DOCKETED	
Docket Number:	11-AFC-04
Project Title:	Rio Mesa Solar Electric
TN #:	233546
Document Title:	Applicant's Supplemental Response to Data Request 16 and 26 Additional Information Regarding Transmission System Engineering
Description:	N/A
Filer:	Marichka Haws
Organization:	California Energy Commission
Submitter Role:	Commission Staff
Submission Date:	6/19/2020 2:45:37 PM
Docketed Date:	6/19/2020

APPLICANT’S SUPPLEMENTAL RESPONSE TO DATA REQUEST 16 AND 26: ADDITIONAL INFORMATION REGARDING TRANSMISSION SYSTEM ENGINEERING

In this section of Applicant’s Supplemental Response to CEC Staff Data Requests 16 and 26, Applicant describes the changes to the Transmission System Engineering section that will result from the changes to the Project Description relating to the removal of Unit 3. Per staff’s request, Applicant uses a strike-out/underline format to identify changes to the Transmission System Engineering section of the Application for Certification that will result from the changes to the Project Description.

DSGN	JPG	06/19/12		BRIGHTSOURCE ENERGY	JOB NUMBER	REV
		DRN	RH	06/19/12		RIO MESA SOLAR	123272	A
		CKD	KBB	06/19/12		220 kV TRANSMISSION LINE		
		SCALE: NTS				TANGENT SINGLE CIRCUIT	DRAWING NUMBER	
		FOR 8.5x11 DWG ONLY				DIRECT EMBED CONCRETE POLE	3.3-2	
REFERENCE DRAWINGS							(REV)

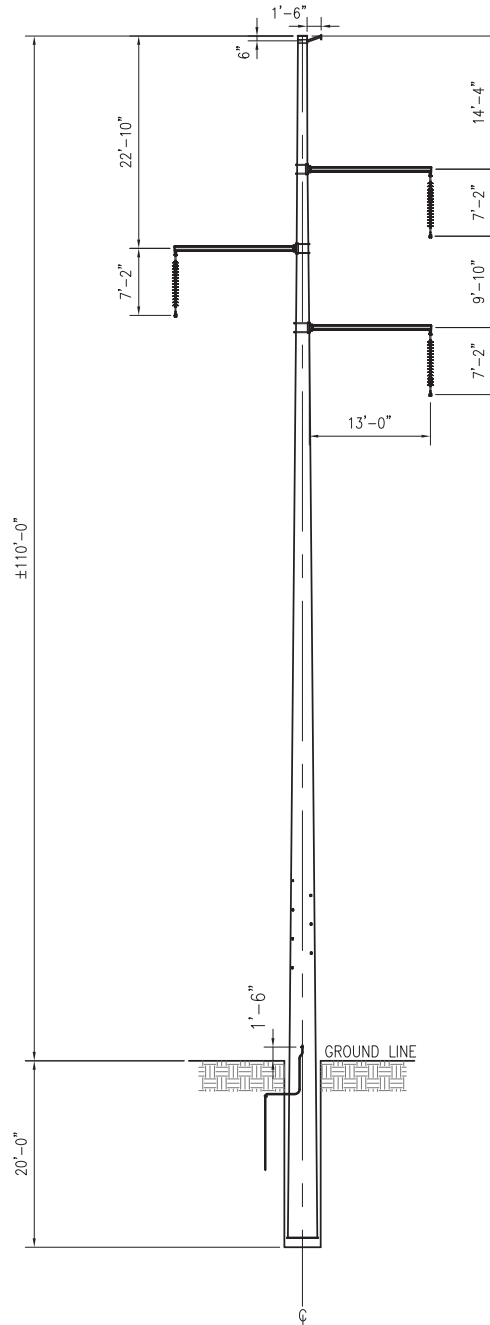
The proposed overhead ~~double-single~~ circuit gen-tie line from the Rio Mesa Switchyard to SCE's CRS will be engineered for operation at 220 kV, nominal. The ~~double-single~~ circuit line will be supported by single-pole structures at appropriate intervals with final heights as determined during final design. The lines will be insulated from the poles using glass, porcelain or polymer insulators, engineered for safe and reliable operation. Figure 3.3-2 illustrates the conceptual design of a typical ~~double~~[single](#)-circuit structure. These pole designs were engineered to provide conceptual design limits for purposes of the EMF studies. Final design will be based on actual field conditions and site requirements.

- The conductor spacing was assumed to be as labeled on the structure drawing (L0-2 Rev. A) provided for reference. Should a different configuration be used, the results may vary significantly.

The data and assumptions used for the EMF and corona effects studies are discussed in the following paragraphs and illustrated in Figures 3.4-1 through 3.4-5 [\(rev\)](#). The cross section of the pole used to calculate the EMF and corona effects is illustrated in Figure 3.3-2. The study calculations are based on the preliminary conceptual design of the interconnection facilities.

Figure 3.4-2

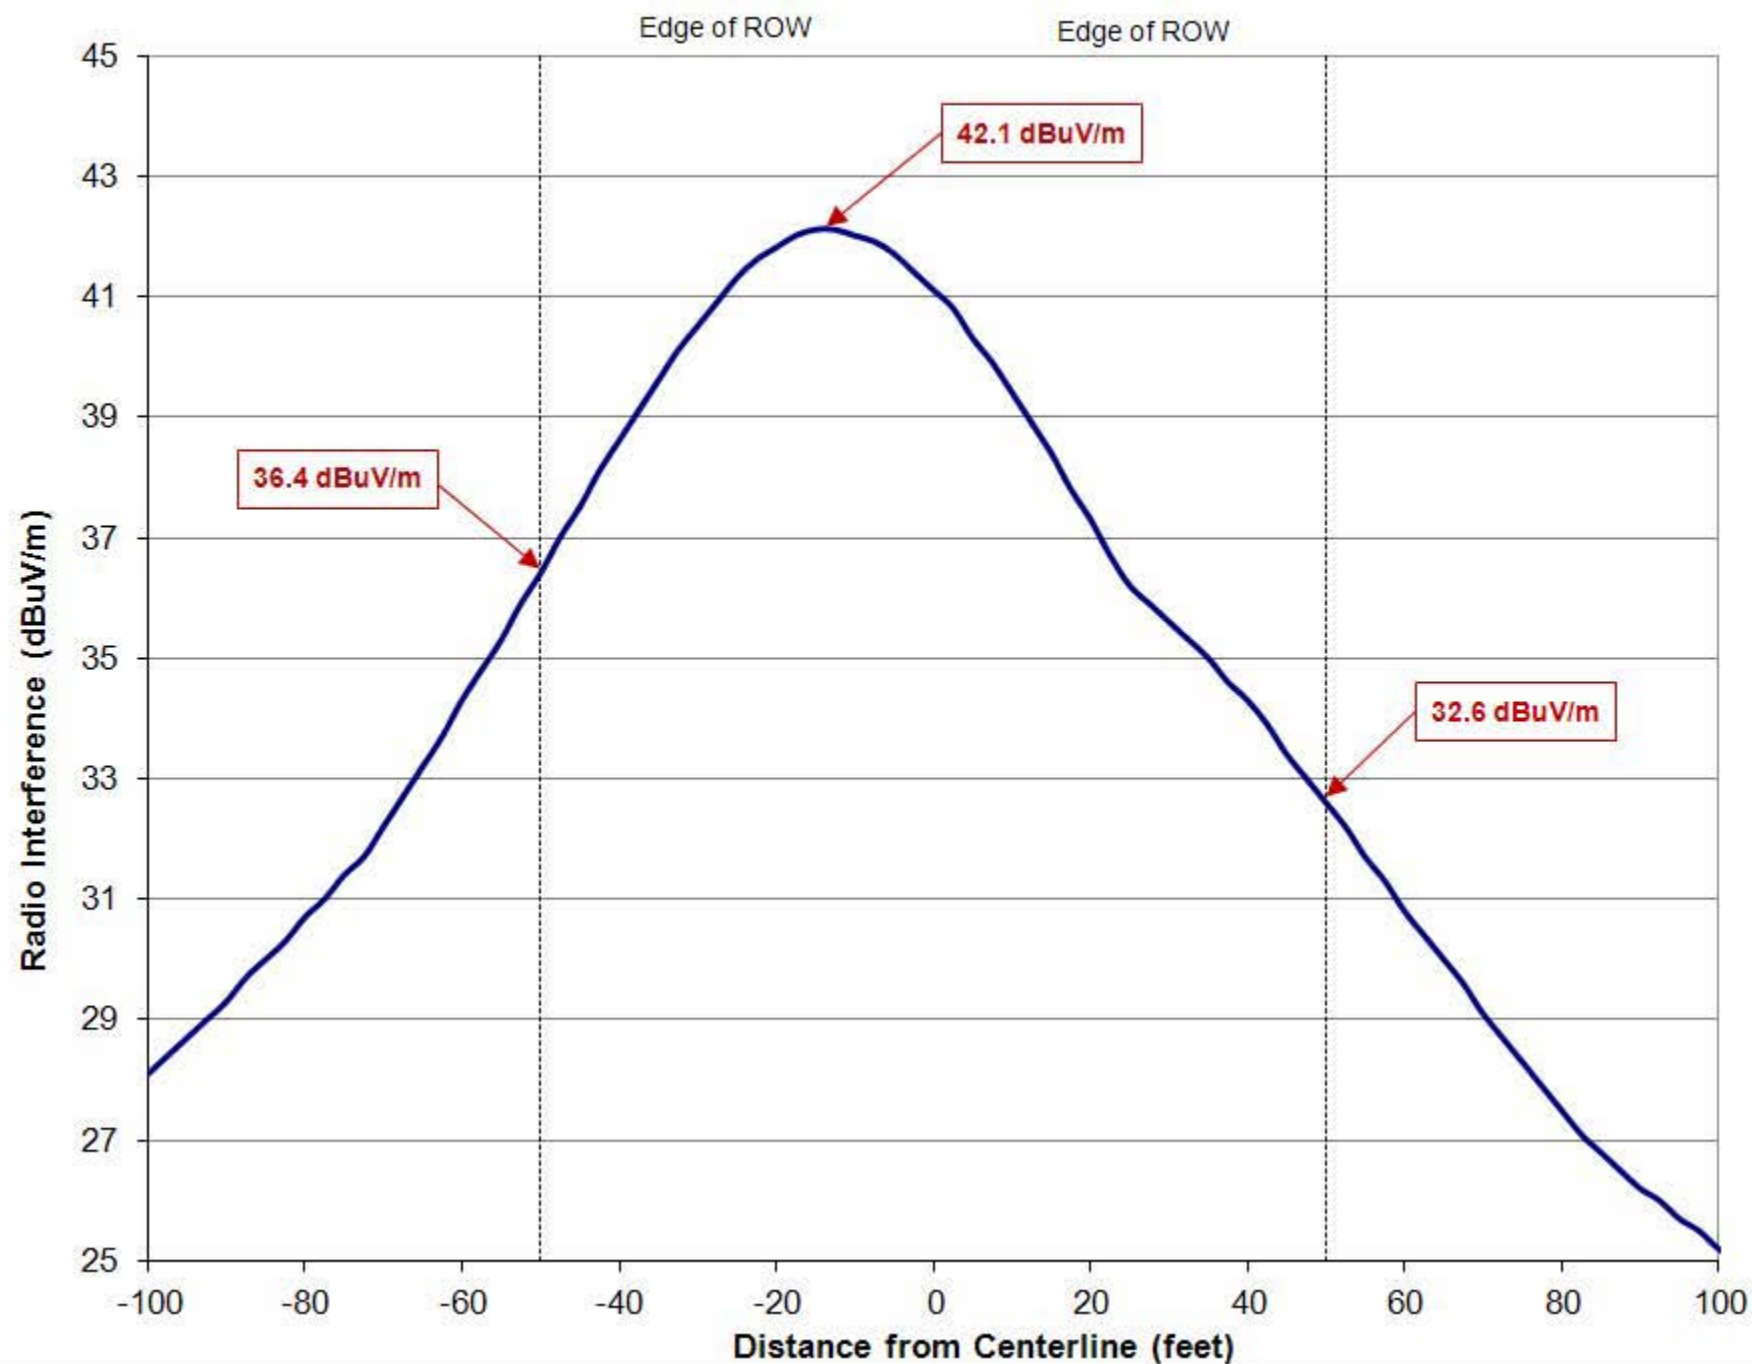
The corona-produced RI may affect AM radio reception but not FM radio reception. Calculations were performed at a reference frequency of 1 MHz (near the middle of the AM band). While RI is greater in rainy weather, the AM signals are more distorted by the atmospheric conditions than any corona sources. Therefore, results are presented in fair weather conditions (consistent with typical industry practice). The RI produced by the 220 kV line during fair weather conditions is shown in Table 3.4-3 and Figure 3.4-2 (rev).

Radio Interference (L50 Rain -Fair dBuV/m)	
Distance From Centerline (feet)	Rio Mesa
90-100	31.528.1
72-80	33.830.7
54-60	36.634.3
-50 (Edge of ROW)	36.4
36-40	40.738.6
18-20	43.441.8
Centerline	42.241.1
1820	43.437.3
3640	40.734.3
50 (Edge of ROW)	32.6
5460	36.630.8
7280	33.827.5
90100	31.525.2

Figure 3.4-3

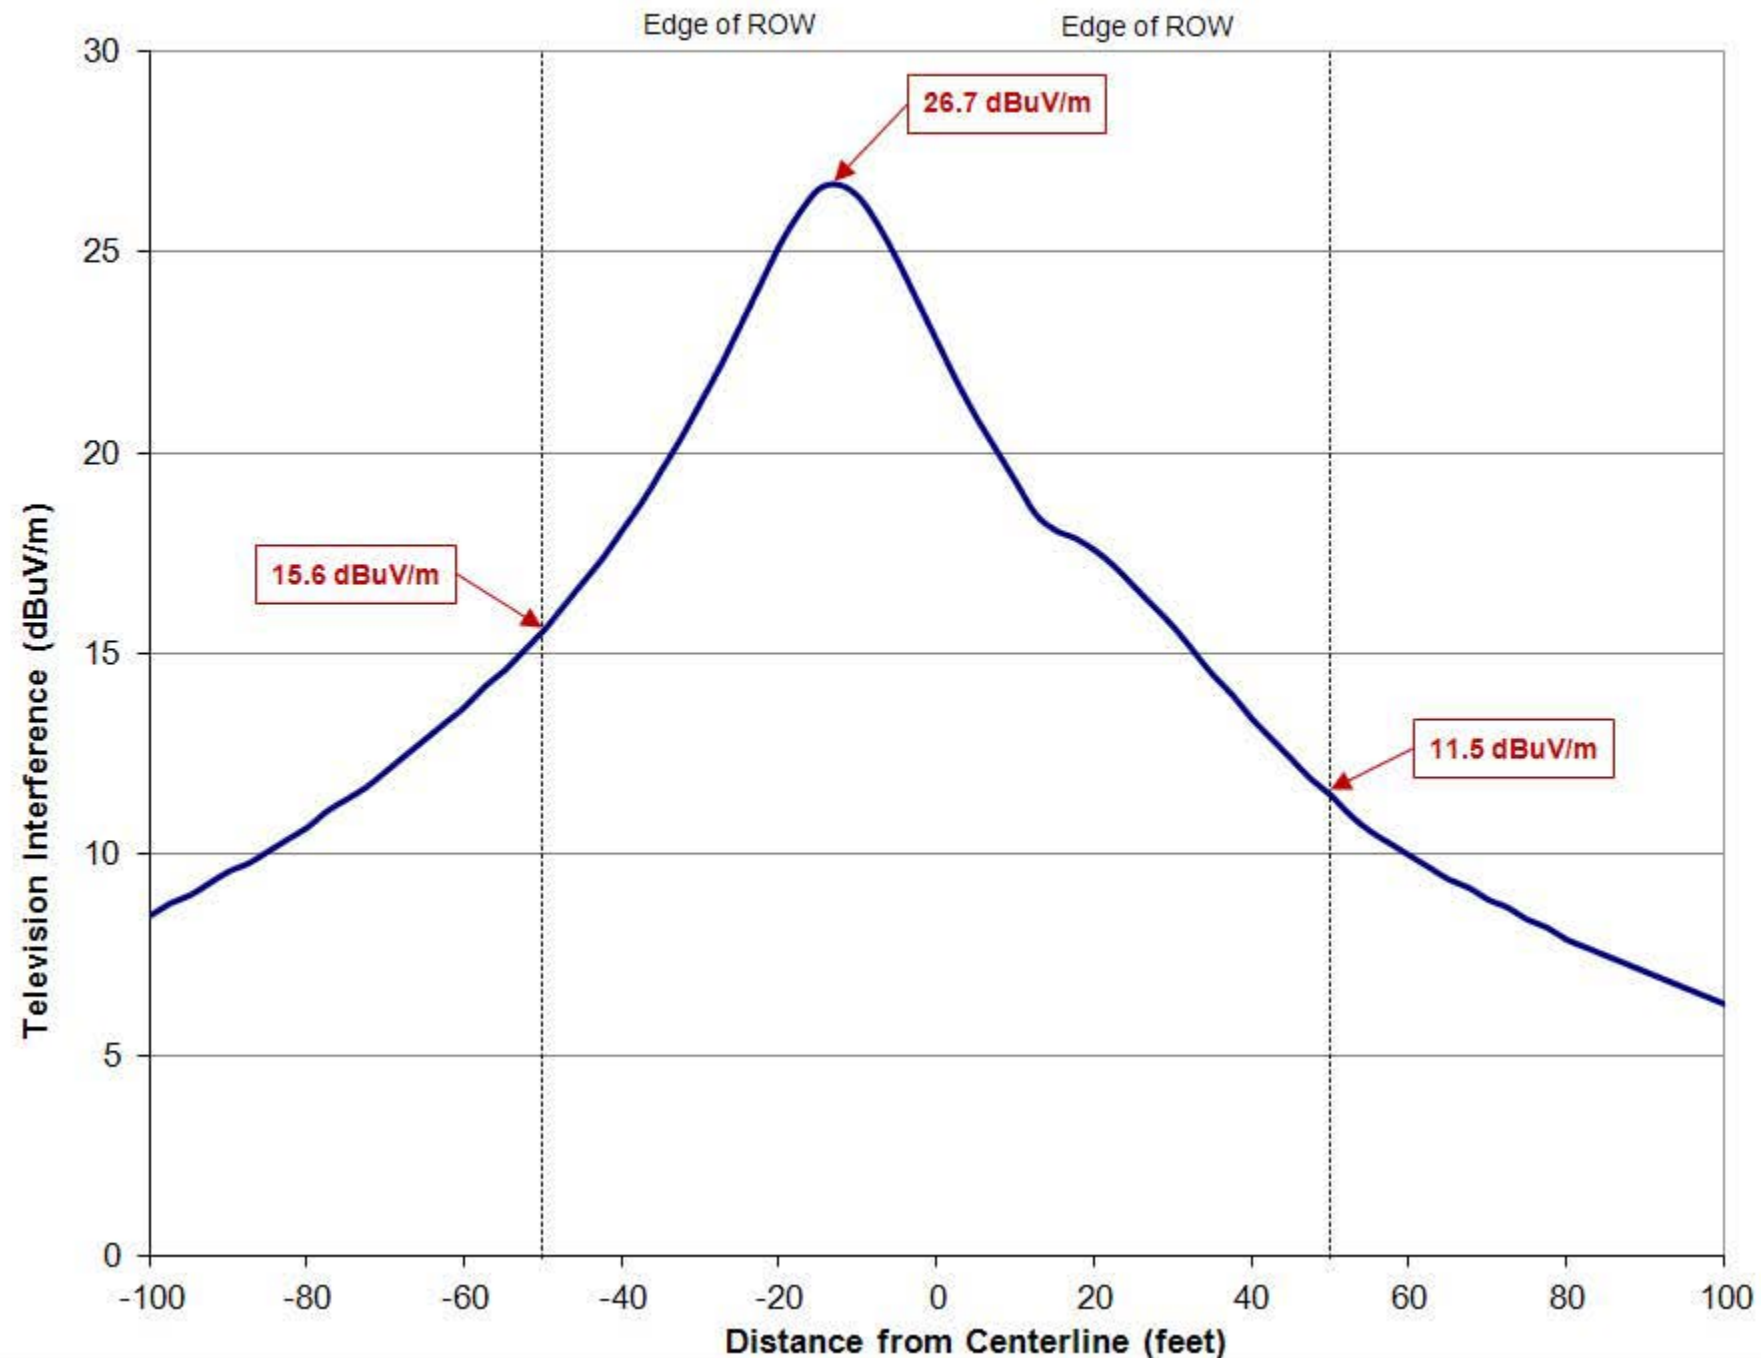
The corona-produced TVI is calculated using the average conductor height with the results reported at a height of ten meters (32.8 feet) above the ground and at the edge of the ROW per FCC guidelines. During fair weather conditions TVI effects are generally negligible so effects during rainy weather are calculated and reported. Television interference is not expected to be a concern due to digital television signals being less susceptible to interference than analog signals. The TVI produced by the 220 kV line during rainy weather conditions is shown in Table 3.4-4 and in Figure 3.4-3 [\(rev\)](#).

Television Interference (Rain dBuV/m)	
Distance From Centerline (feet)	Rio Mesa
90-100	40.5 8.5
72-80	12.9 10.7
54-60	16.0 13.7
-50 (Edge of ROW)	15.6
36-40	20.7 18.1
18-20	28.6 25.2
Centerline	23.9 22.8
18-20	28.6 17.6
36-40	20.7 13.4
50 (Edge of ROW)	11.5
54-60	16.0 10.0
72-80	12.9 7.9
90-100	40.5 6.3

Figure 3.4-4

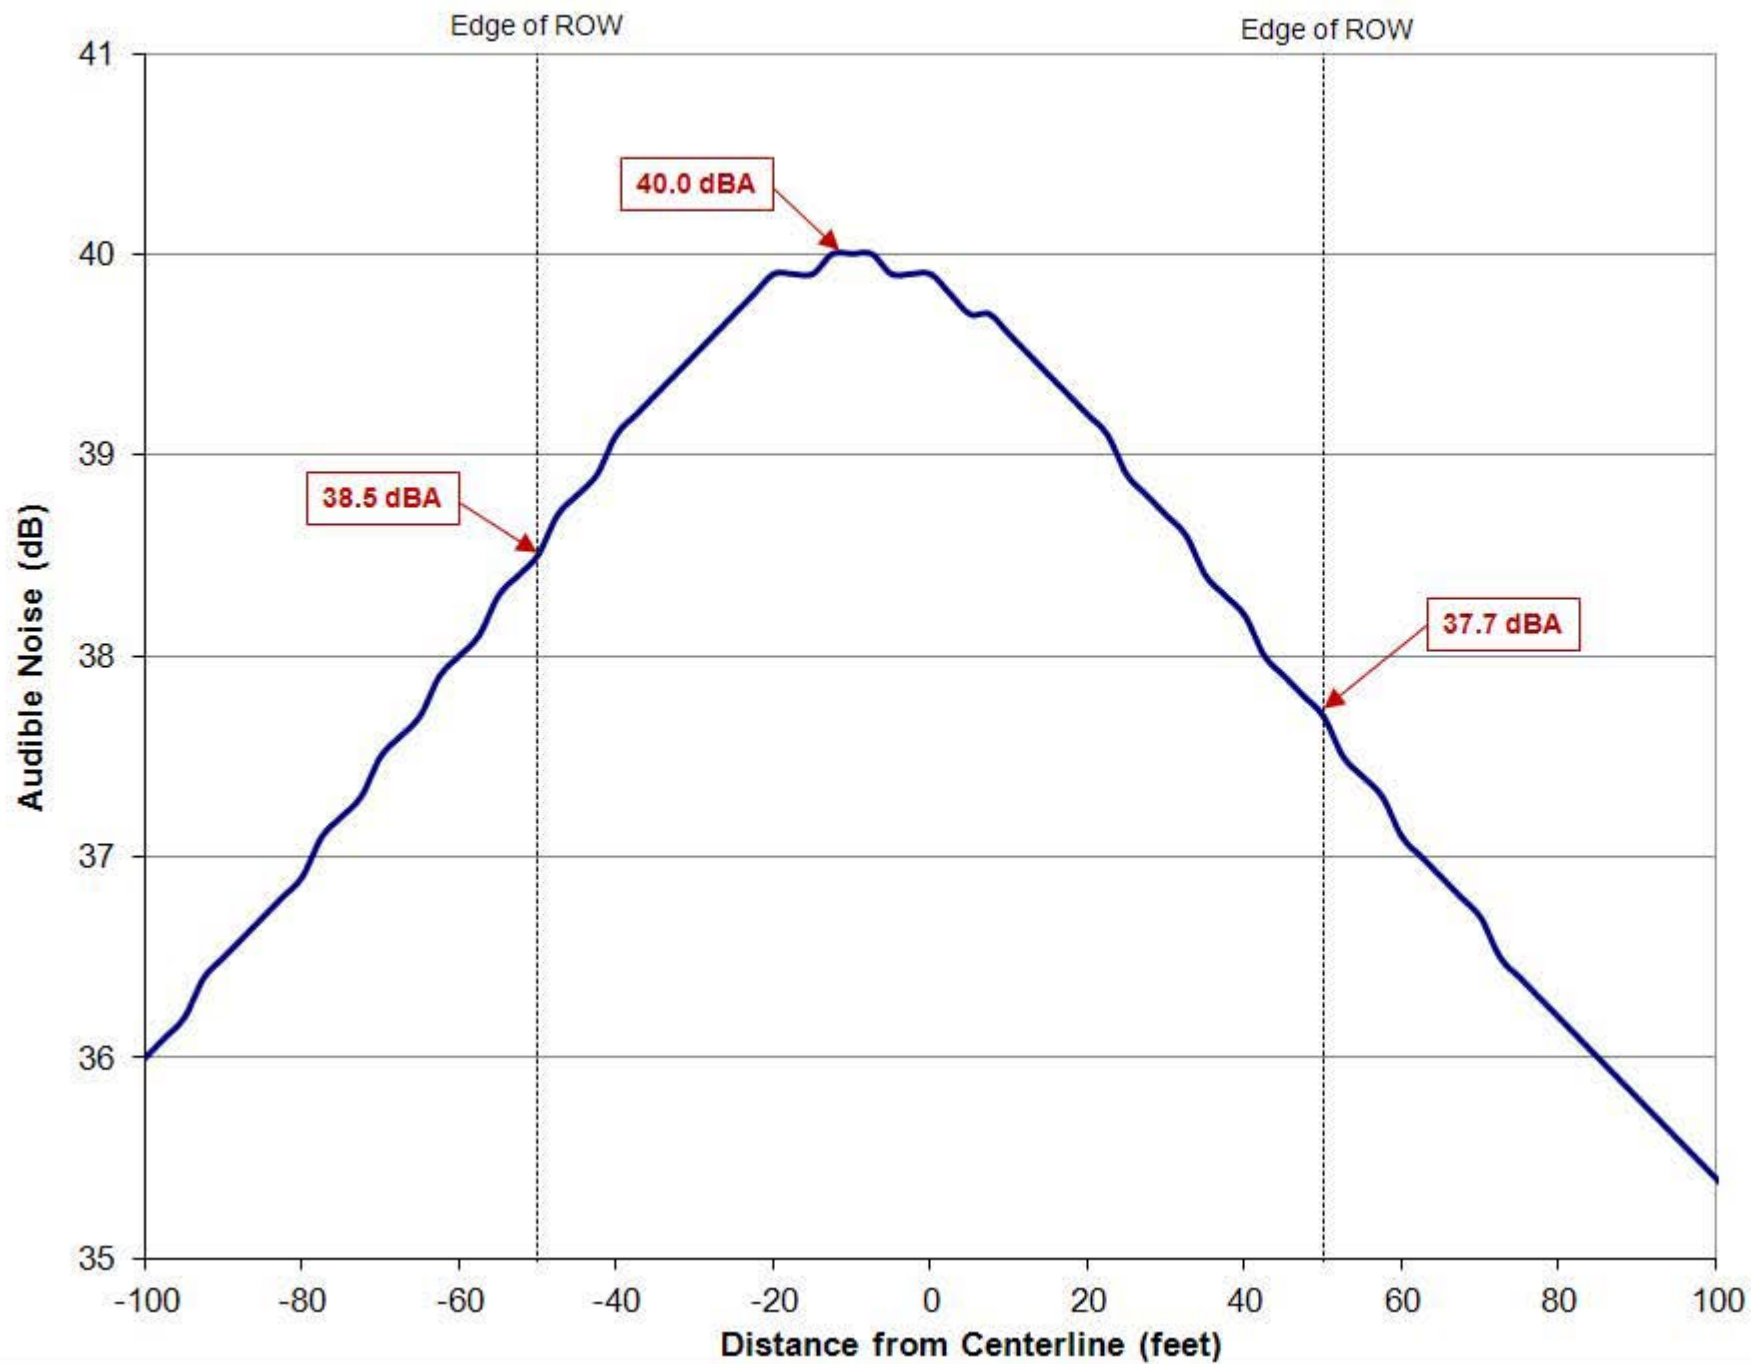
In fair weather, the audible noise will not be observable by a person standing at ground level. During rain, the noise level will be higher but will be masked by the sound of the falling raindrops as well as ambient noise. The audible noise produced for the 220 kV lines during rainy weather as measured 5 feet above ground is shown in Table 3.4-5 and in Figure 3.4-4 [\(rev\)](#).

Audible Noise (L50 Rain dBA)	
Distance From Centerline (feet)	Rio Mesa
90-100	41.1 36.0
72-80	41.9 36.9
54-60	42.8 38.0
-50 (Edge of ROW)	38.5
36-40	43.6 39.1
18-20	44.3 39.9
Centerline	44.5 39.9
18-20	44.3 39.2
36-40	43.6 38.2
50 (Edge of ROW)	37..7
54-60	42.8 37.1
72-80	41.9 36.2
90-100	41.1 35.4
